Appendix 3: BRIDGE SUMMARY- RAUMATI BRIDGE
Site Specific Management Plan 002 [Sectors 330-340-350]
MacKays to Peka Peka Expressway
M2PP-121-D-PLNM-002

02 September 2014 - REV C

PROPOSED PLAN- RAUMATI ROAD BRIDGE - 1:500@A3

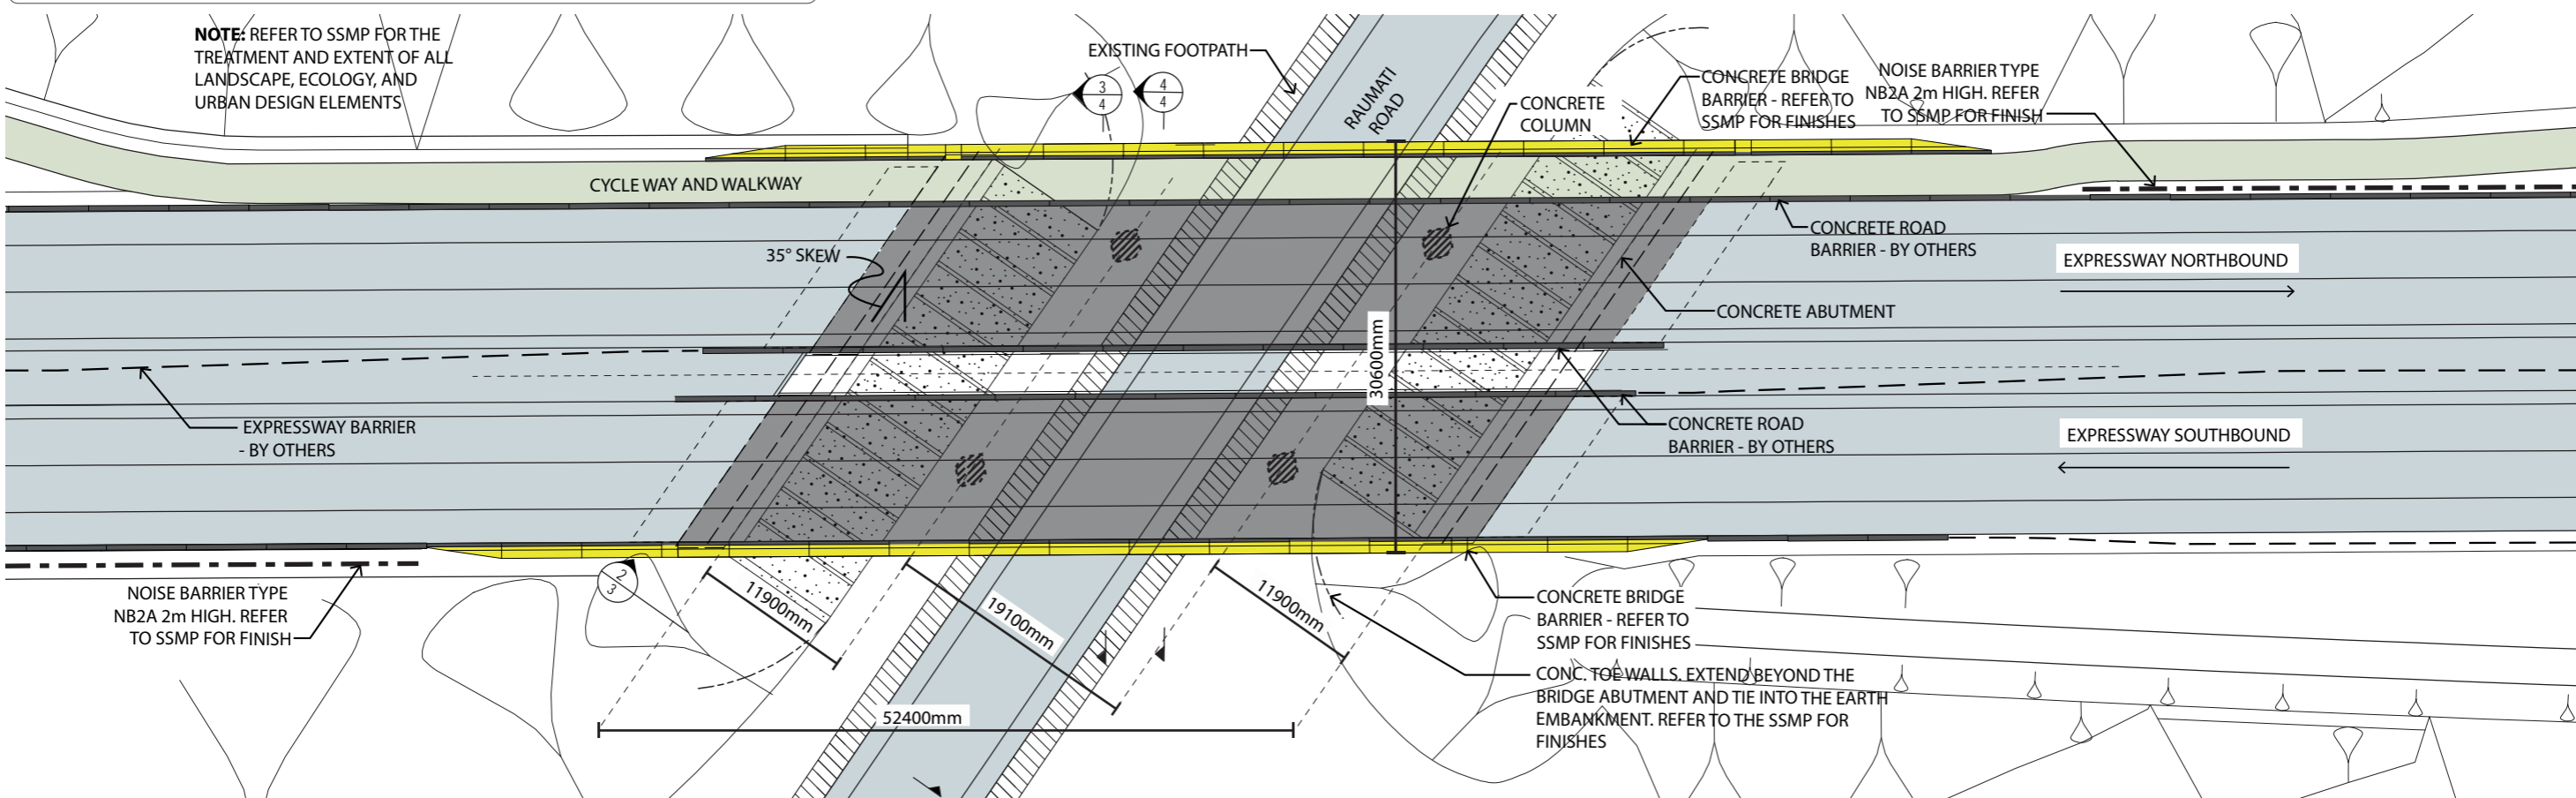
1. Further detail provided for abutment treatment.
2. Column shape and location changed.
3. Local road drawn correctly.
4. Reduced overall length of the bridge.

1. Spill through abutment design developed to better integrate the abutment panels with the expressway embankments and local road
2. Moving the columns inboard resolves the issue with the bridge skew angle and the interface between columns and the bridge barrier/fascia panels.
3. No change to local road proposed - Proposed plan indicates optimum local road design (17m corridor).
4. Change from Hollow Core to Super T beams.

2. PROPOSED ELEVATION - RAUMATI ROAD BRIDGE EAST ELEVATION - 1:250@A3

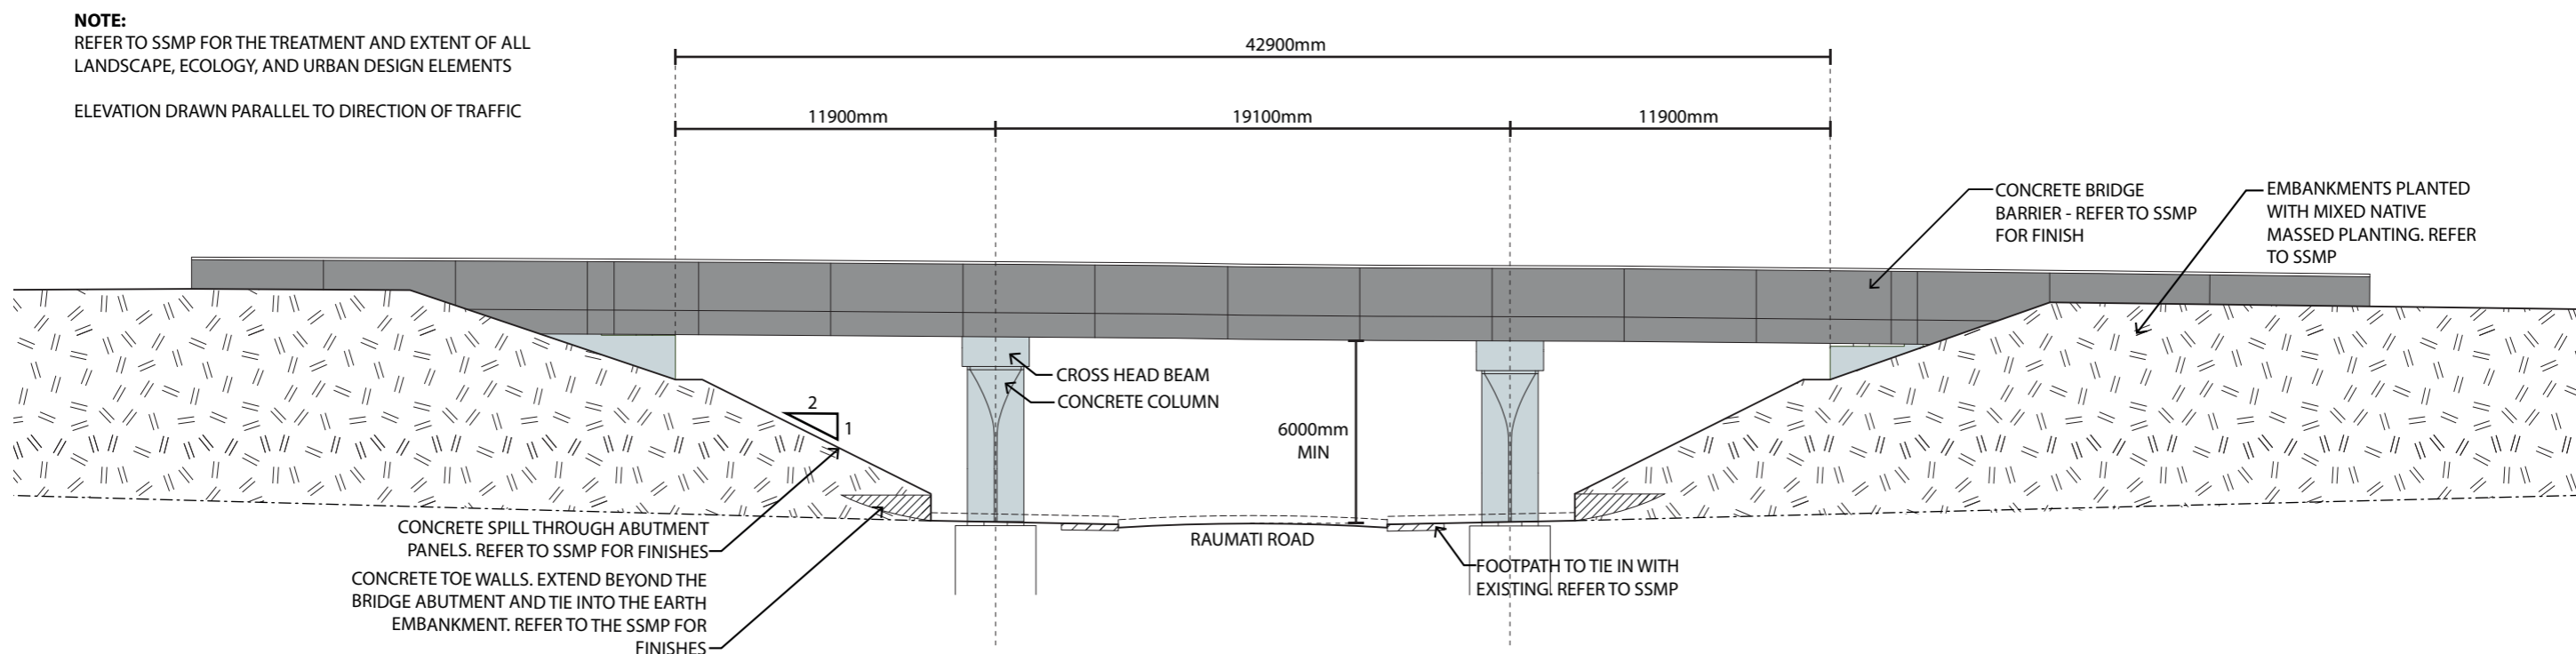
1. Bridge barrier/fascia panel drawn higher
2. Reduced overall length of the bridge
3. Bridge abutment appears to be steeper
4. Column profile developed

1. Barrier drawn incorrectly in AEE elevation. Change to beam size and type to suit structural requirements of the high skew
2. The AEE elevation was drawn incorrectly. It was drawn perpendicular to the barrier but did not show the skew of the columns. Change from Hollow Core to Super T beams
3. Due to the angle that each elevation has been drawn and the skew of the bridge the abutment will appear steeper no change proposed.
4. Increased structural core based on geotech investigations carried out post AEE, while still providing the sculptural outer.

3. PROPOSED SECTIONAL ELEVATION - RAUMATI ROAD BRIDGE SOUTH ABUTMENT - 1:200@A3

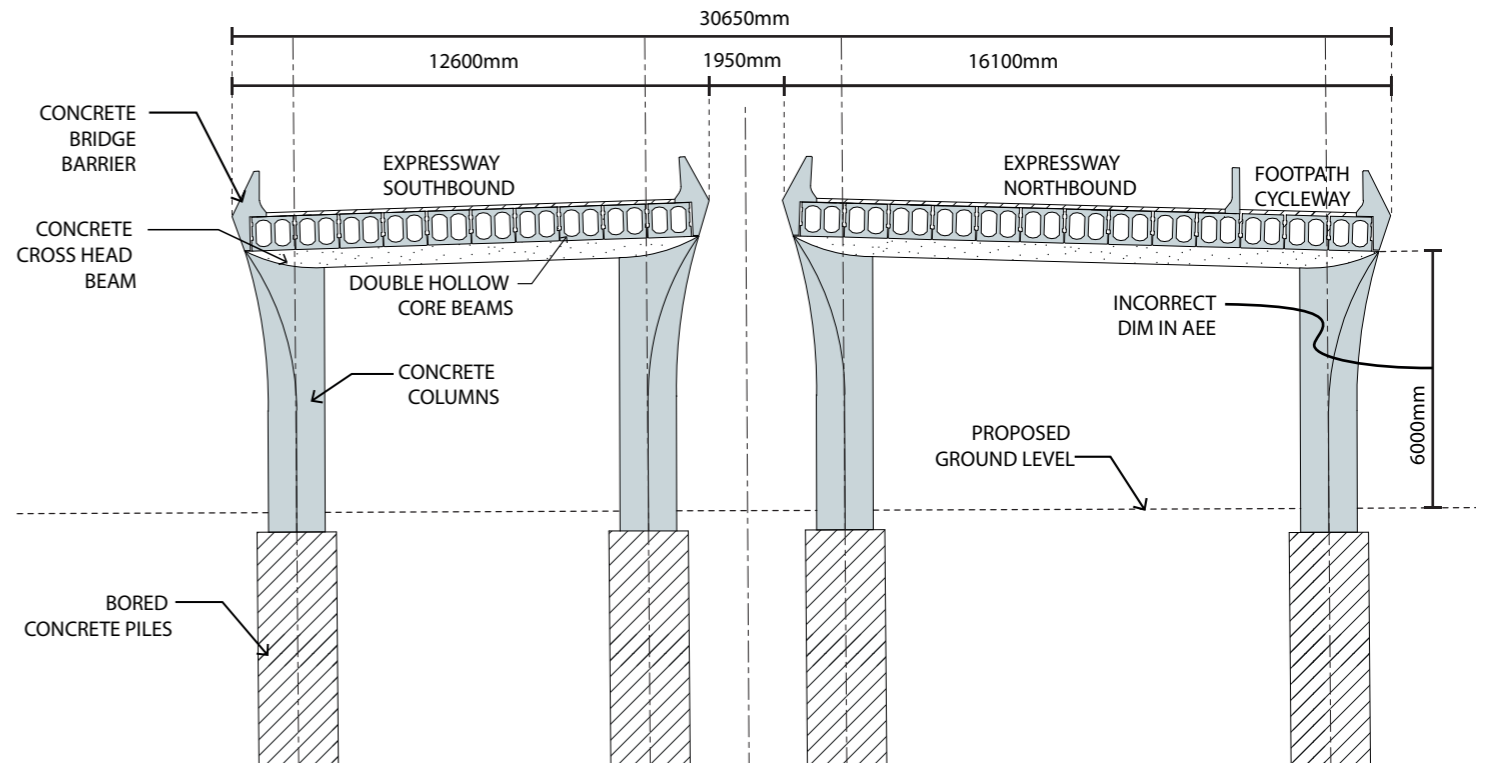
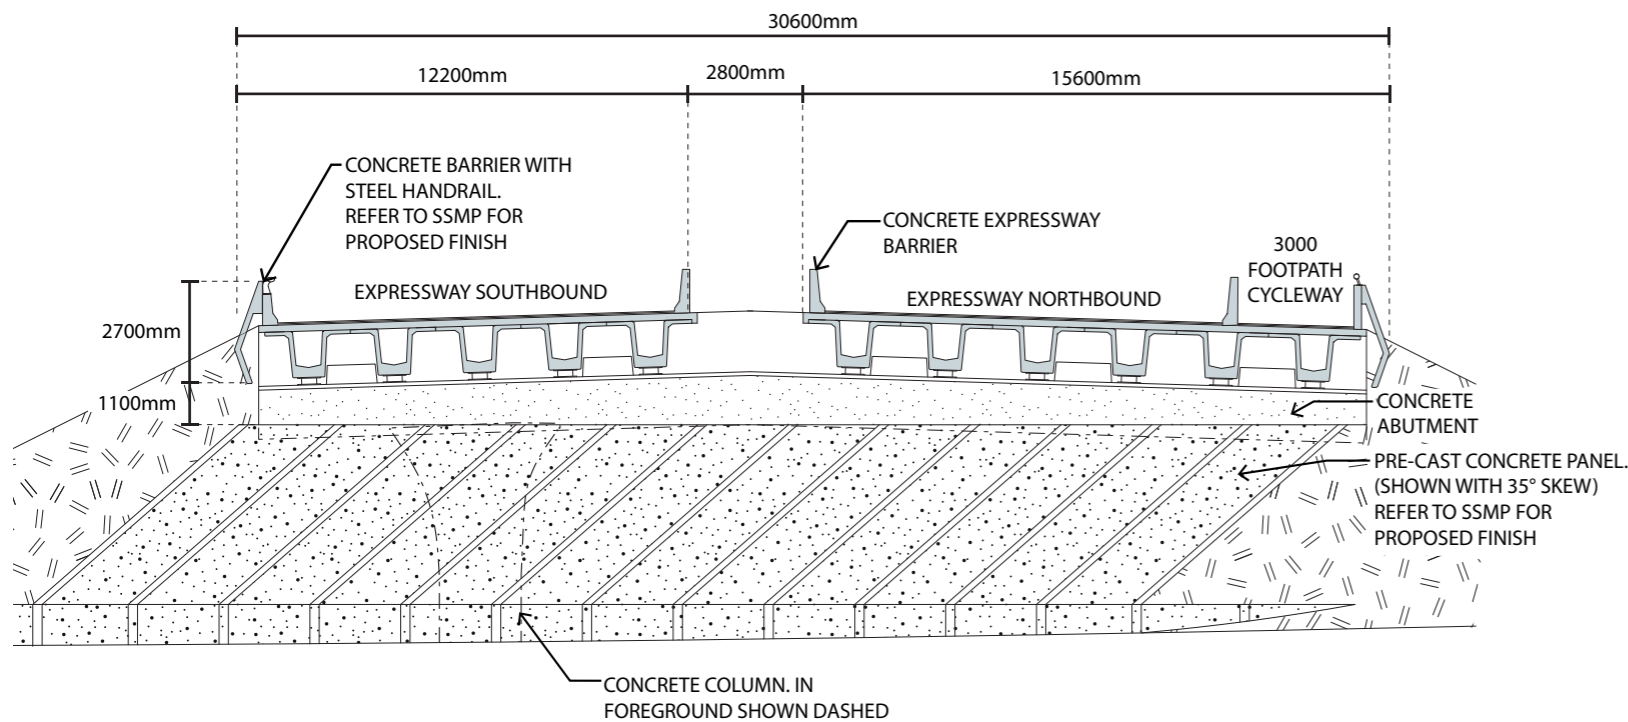
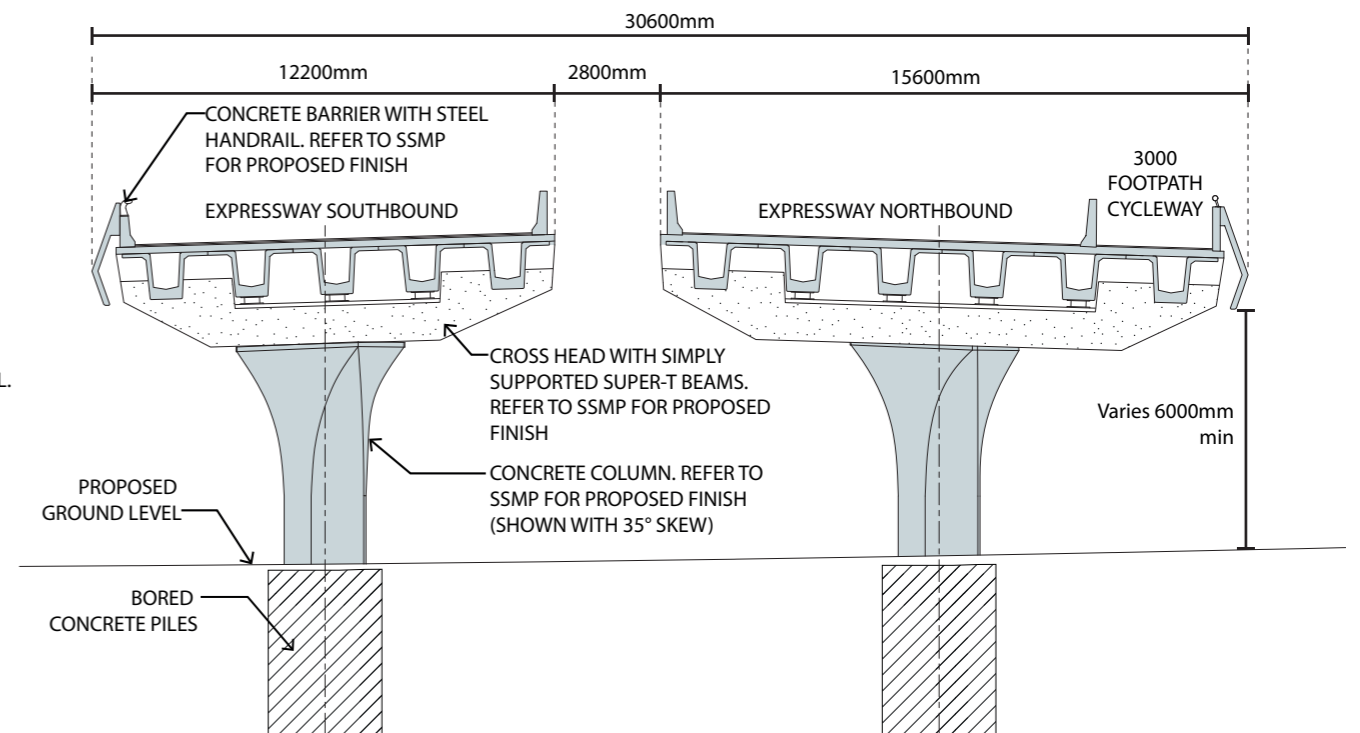
1. Reduced number of columns; 2 columns to 1 column for each cross head
2. More detail provided for abutment treatment
3. Cross head form changed
4. Column profile developed

5. Change to beam size and type. Change to simply supported structure.

1. Improved visual permeability when considering bridge skew. Total column width when combined is reduced
2. Lack of resolution in AEE. Abutment design developed
3. Simply supported structure requires platform to seat beams
4. Increased structural core based on geotech investigations

5. carried out post AEE, while still providing the sculptural outer. Constructability issues because of seismic requirements. Integral connections difficult to build without increasing structural element sizes further.
